ADDENDUM NO. 2

TO: PLANS AND SPECIFICATIONS FOR STATE OF MISSOURI

**Shady Grove State School – Replace HVAC and Controls
Poplar Bluff, Missouri
PROJECT NO.: E2010-01**

1 FIRST FLOOR PLAN - ELECTRICAL POWER
1/8" = 1'-0"

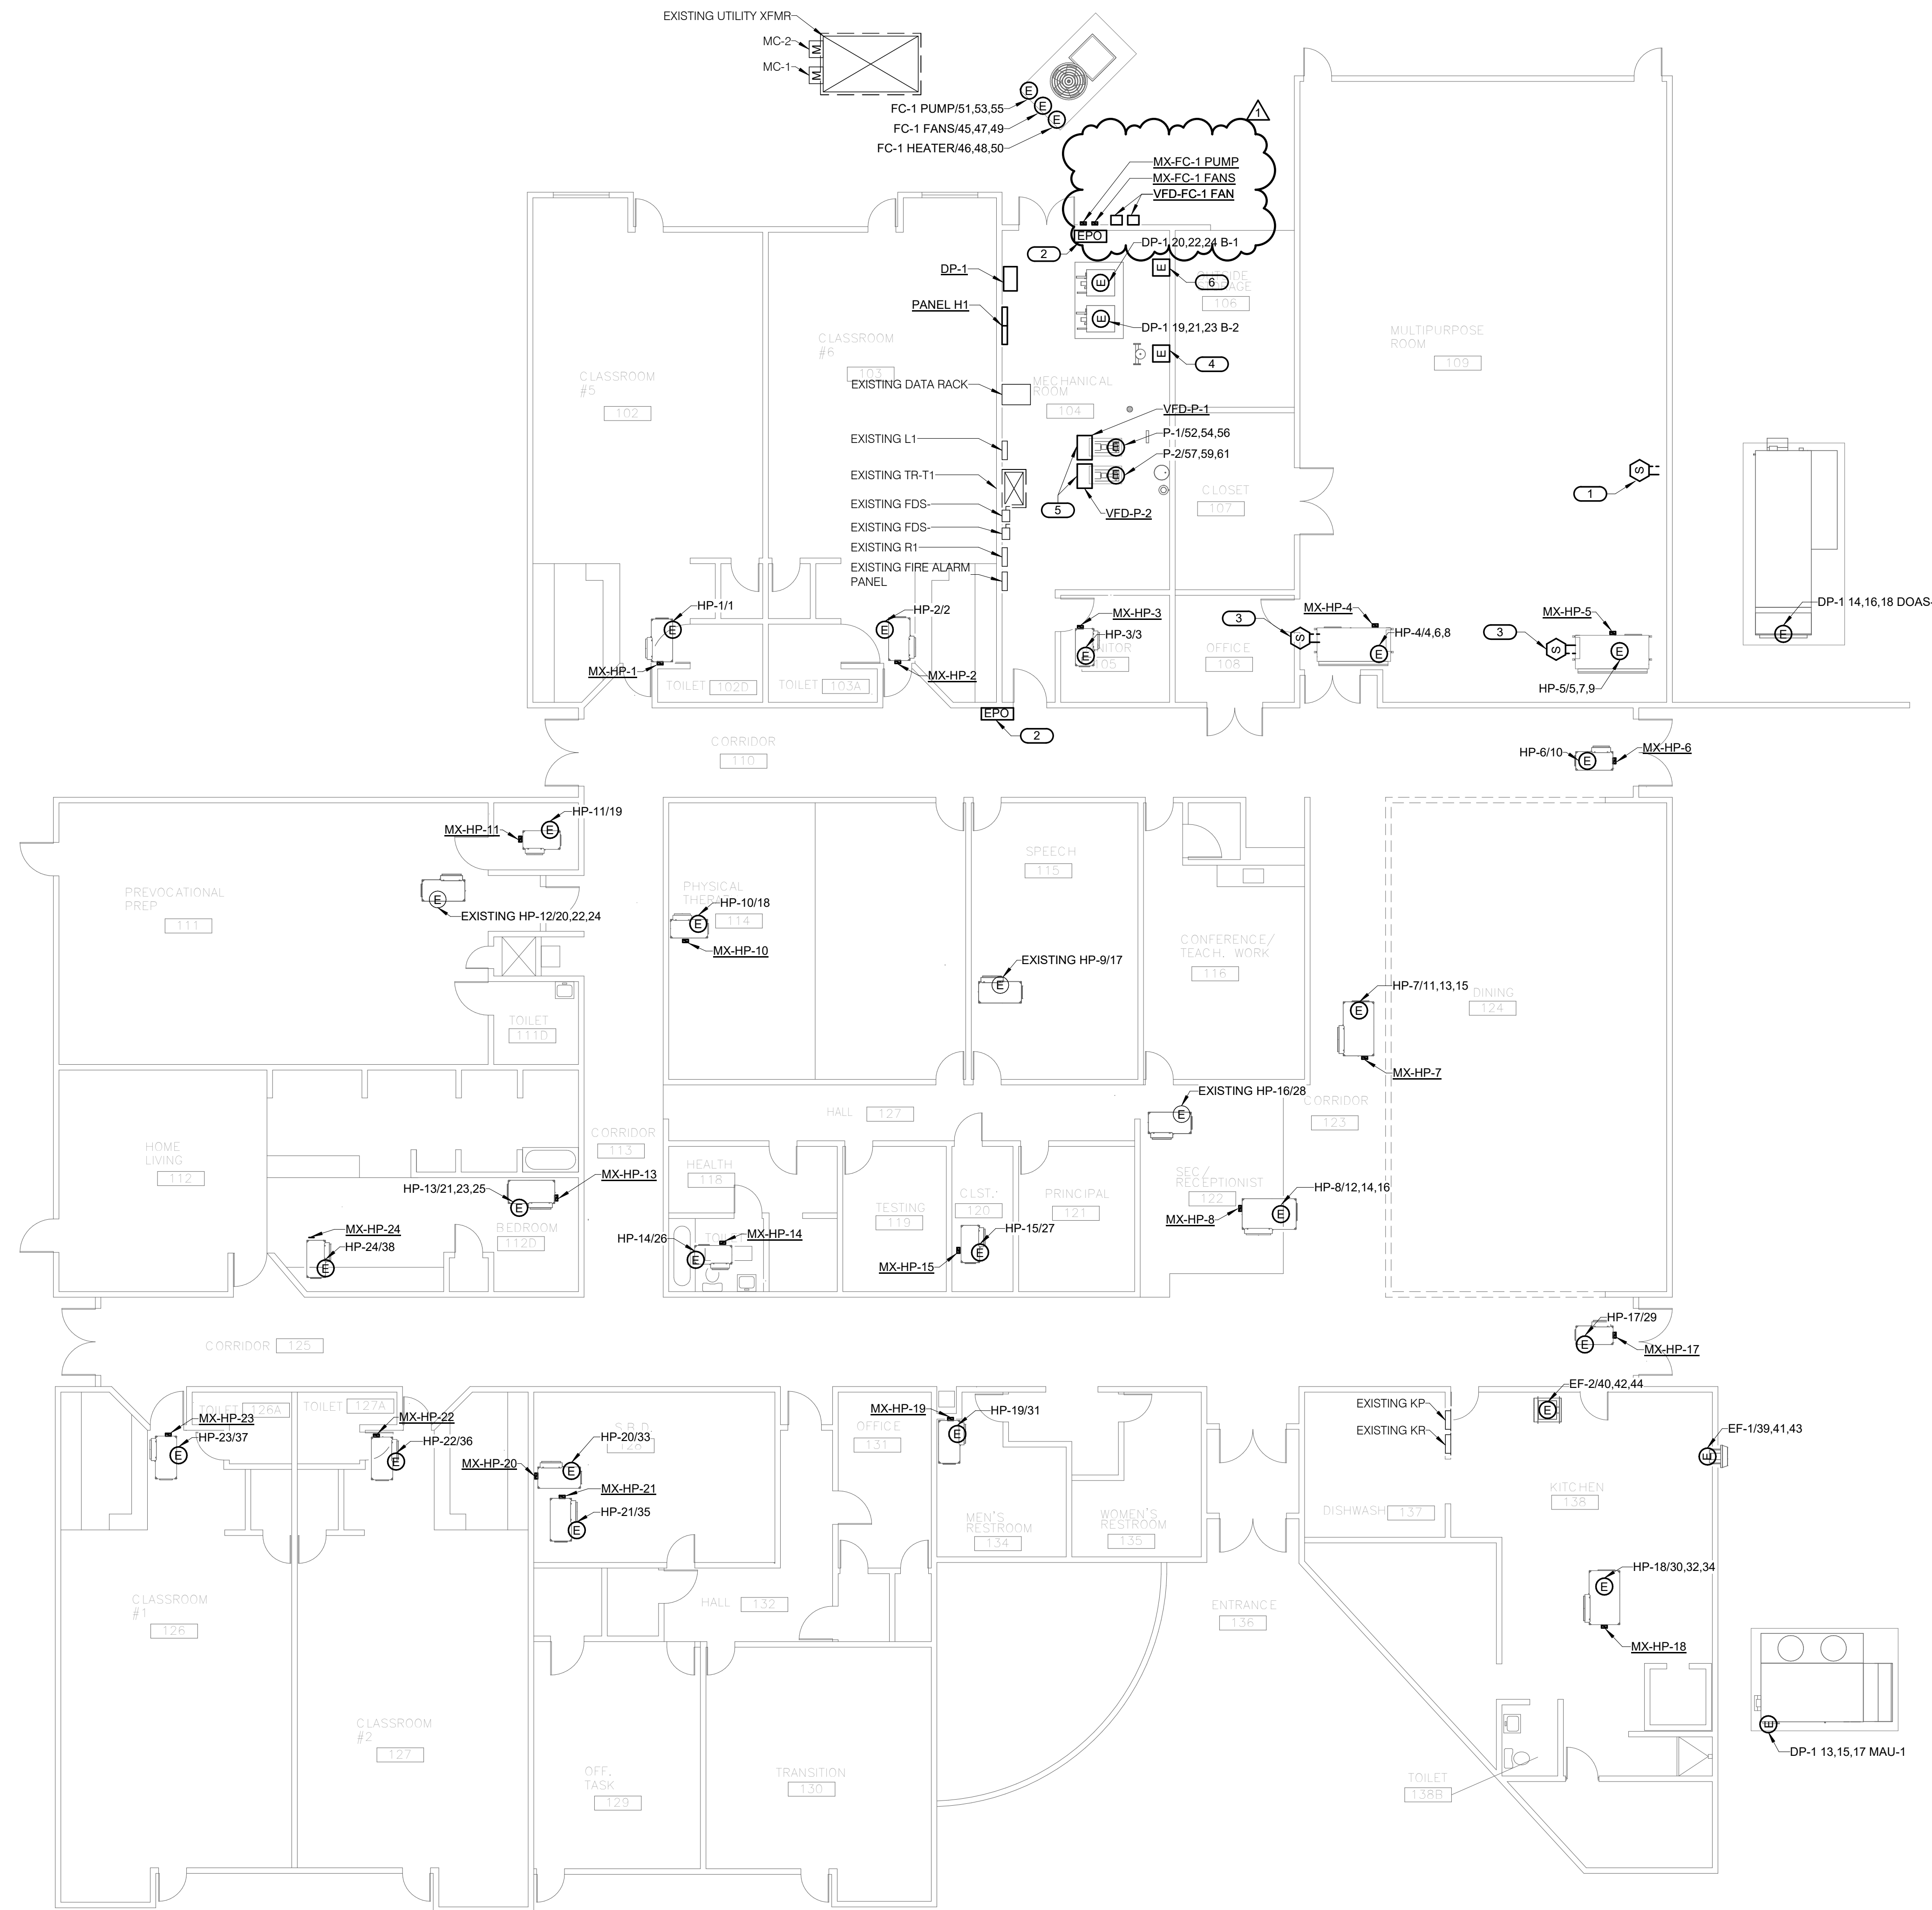
2. Sheet E-100, First Floor Plan - Electrical Power
 - a. ADD MX-FC-1 PUMP to exterior wall.
 - b. ADD MX-FC-1 FANS to exterior wall.
 - c. ADD (2) VFD-FC-1 FAN to exterior wall.
3. Sheet E-500, Electrical Schedules
 - a. ADD MX-FC-1 PUMP to Disconnect and Starter Schedule.
 - b. ADD MX-FC-1 FANS to Disconnect and Starter Schedule.
 - c. ADD (2) VFD-FC-1 FAN to Variable Frequency Drive Schedule.
